Access Compliance Report

Public Rights-of-Way

(Curb Ramps)

Intersection ID: 14547	Main Street: EAST_BV	Cross Street: SPRINGDALE_AV	Location: W
ADA ID: 2FB4BD032B49	Ramp Type: Directional1	Initial Pass/Fail: Pass	Overall Compliance: No
Codes/Mitigation Info/Possible Solution		Field Measurements/Component Compliance	
Severity Score: 0.25

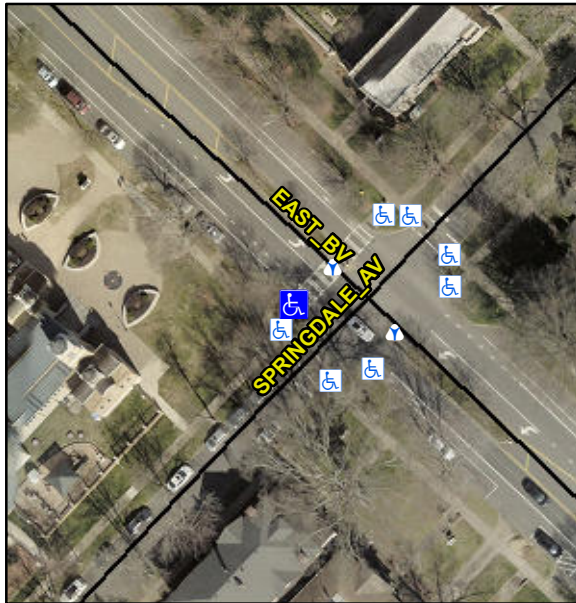
Surveyor Notes:

LNDG SLOPE NEGATIVE

PROW/ADA:

R304.5.3, R304.2.2-Perp, R304.3.2-Para

Possible Solutions:

**Remove & Replace Entire Ramp.
Remove & Replace Gutter.**
